# UNITED STATES PATENT AND TRADEMARK OFFICE

APPLICATION NO.	FILING DATE	FIRST NAMED INVENTOR	ATTORNEY DOCKET NO.	CONFIRMATION NO.
10/559,377	06/13/2006	Markus Raab	095309.57134US	2882

<b>Office Action Summary</b>	<b>Application No.</b> 10/559,377	<b>Applicant(s)</b> RAAB, MARKUS	
	<b>Examiner</b> WAE LOUIE	<b>Art Unit</b> 3661

## **DETAILED ACTION**

**FIG. 4B**

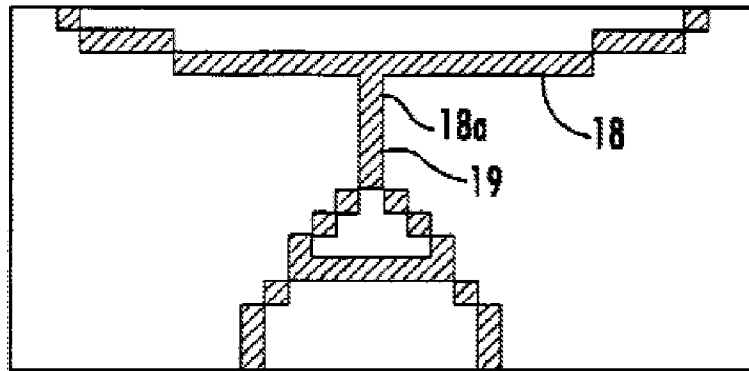
McMahon does disclose the image of the hitch alignment as shown in Fig. 4B but does not disclose the evaluating the rate of change of geometric characteristics of the image and detected contour of the semi-trailer or trailer. Piper et al utilizes acoustic transducers that aid in the alignment of the hitch. The transducers evaluate the rate of change of the geometric characteristics based on the reflection of ultrasonic sound. It would have been obvious to one of ordinary skill in the art at the time of invention to utilize any number of sensors like that of Piper to determine the angle of the trailer of McMahon since this is readily available in the art and a well-known technique.
